DATE: April 6, 2022

TO: Design Review Commission
FROM: Sean K. Gallegos, Assistant Planner
SUBJECT: SC21-0027, 2256 Deodara Drive

PROJECT DESCRIPTION

Showing trees #9-11

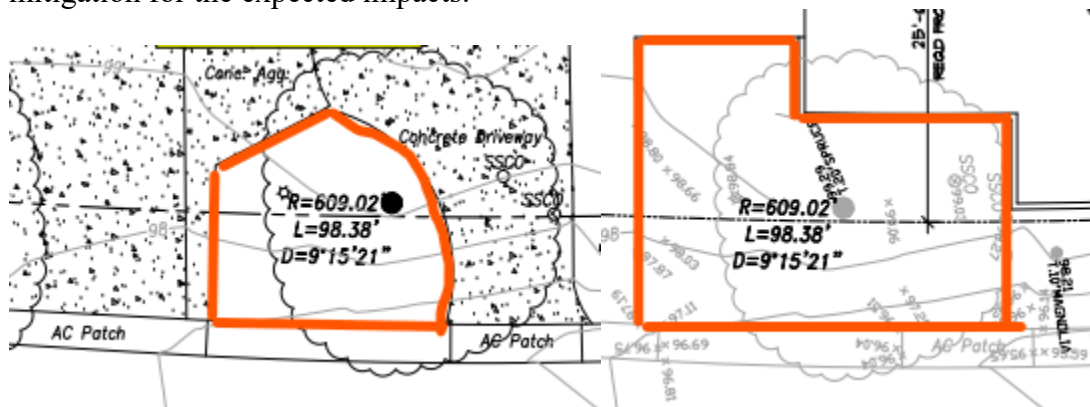
Deodar cedar trees #9 and #10 are proposed for removal to facilitate the construction of the new driveway/retaining wall. A new retaining wall is proposed at the root crown of the trees. Cutting roots at the retaining wall would have a high impact on the health and stability of these trees; therefore, tree removal is recommended.

Magnolia tree #11 is nearly dead and not expected to improve. Construction will only lead to further tree decline. Tree removal is recommended.

Showing recommended tree protection fencing locations

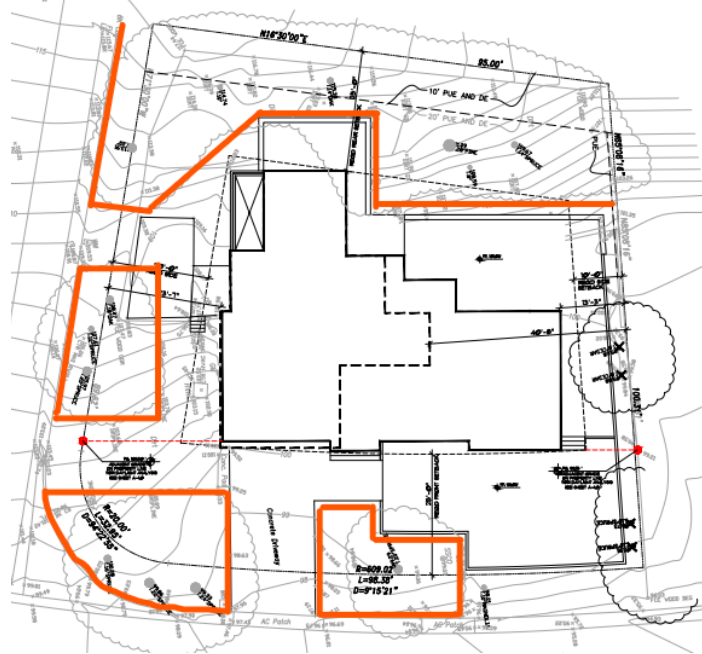
Tree protection zones should be installed and maintained throughout the entire length of the project. Prior to the commencement of any Development Project, a chain link fence shall be installed at the drip line (canopy spread) of any protected tree which will or will not be affected by the construction. Non-protected trees to be retained shall also be protected in the same way. The drip line shall not be altered in any way so as to increase the encroachment of the construction. When work is to take place underneath a tree's dripline, fencing must be placed as close as possible to the tree proposed work. If an area of access is needed underneath a tree's canopy, the area shall be protected by a landscape barrier. Fencing for the protection zones should be 6-foot-tall metal chain link type supported by 2 inch metal poles pounded into the ground by no less than 2 feet. The support poles should be spaced no more than 10 feet apart on center. Signs should be placed on fencing signifying "Tree Protection Zone - Keep Out". No materials or equipment should be stored or cleaned inside the tree protection zones. Excavation, grading, soil deposits, drainage and leveling is prohibited within the tree protection zones without the project arborist consent. No wires, signs or ropes shall be attached to the protected trees on site. Utility services and irrigation lines shall all be placed outside of the tree protection zones when possible. When access is needed and tree protection fencing restricts access a landscape barrier shall be installed to protect the non-protected root zone.

SECTION A-A

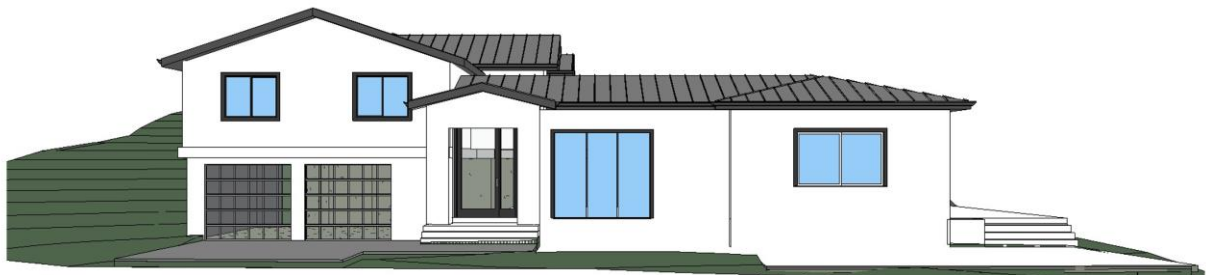
- 1- The first floor roof slope is very shallow and is designed as 3 : 12 to help reduced the overall height.
